Attached is our follow up recommendations per Russ MacAdam's (Director, Lutron Electronics Co., Inc.) comments made at the hearing on February 26, 2007. The proposed changes are for Sections 119, 131, and 146 from the February 2007 revisions of the 2008 Building Energy Efficiency Standards. These recommendations are based primarily on energy savings and clarity. Let me know if have any questions or if you need more information. Thanks for your consideration.

# Title 24

## 2008 Code proposal

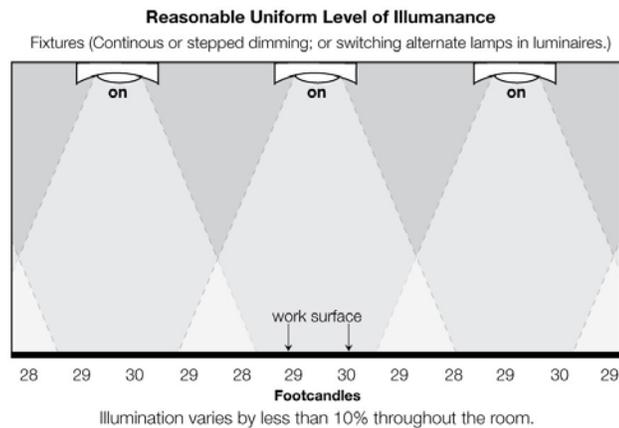
(b) **Multi-Level Lighting Controls.** The general lighting of any enclosed space that has more than one luminaires, is 100 square feet or larger, and has a connected lighting load that exceeds 0.8 watts per square foot shall have multi-level lighting controls. Multi-level controls shall have at least two control steps that are between 30% and 70% of design lighting power and allow the power of all lights to be manually turned off.<sup>4</sup>

<sup>4</sup> Giving users more than one light level between 30% and 70% saves more energy. With only one light level, no energy is saved unless task requires less light than that level provides. With multiple light levels, more energy savings is achieved because users can select the light level appropriate for the task. In a typical office environment, light levels for different tasks can vary from 5 footcandles to 100 footcandles (see 9<sup>th</sup> Edition of the IES Handbook). And studies (Occupant Use of Manual Lighting Controls in Private Offices. IESNA Paper #34, Lighting Research Center, RPI) show that most (74%) users will use lower light levels if given that option.

<sup>5</sup> Reasonable uniform illuminance:

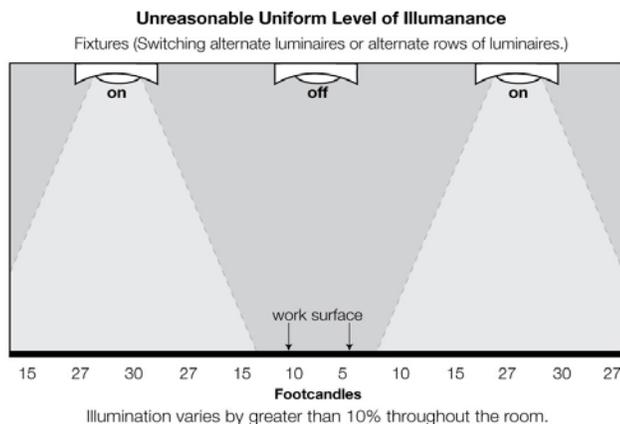
1. A reasonably uniform level of illuminance<sup>5</sup> shall be achieved by any of the following:

<sup>6</sup> Reasonable illuminance cannot be achieved if alternate luminaires or alternate rows of luminaires are switched off. Unreasonable uniform illuminance:
